2007 No. 000

**Traffic Signs (Amendment) Regulations and General Directions
2007**

The Traffic Signs (Amendment) Regulations 2007

The Traffic Signs (Amendment) General Directions 2007

880.1
Speed camera ahead on an unlit road and reminder that a national speed limit applies

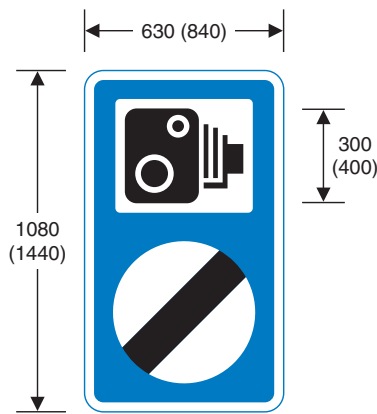
3. In Schedule 4 after diagram 880 insert the diagram 880.1 set out in the Schedule to these Regulations.

Diagram to be inserted into Schedule 4 to the Traffic Signs Regulations 2002

7. Substitute the following for direction 32—
 - “(1) The signs shown in diagrams 878, 879, 880 or 880.1 may be placed only in an area or along a route where enforcement cameras are from time to time in use.
 - (2) The sign shown in diagram 880 may be placed only on or near a road on which—
 - (a) there is provided a system of carriageway lighting furnished by means of lamps placed not more than 183 metres apart in England and Wales or 185 metres apart in Scotland; and
 - (b) which is subject to a speed limit of 30 mph.

- (3) The sign shown in diagram 880.1 may be placed only on or near a road on which—
- (a) there is not a system of carriageway lighting furnished by means of lamps placed less than 183 metres apart in England and Wales or 185 metres apart in Scotland; and
 - (b) a national speed limit is in force.
- (4) No more than two signs of the type shown in diagram 880 or 880.1 may be placed on any approach to an enforcement camera.”
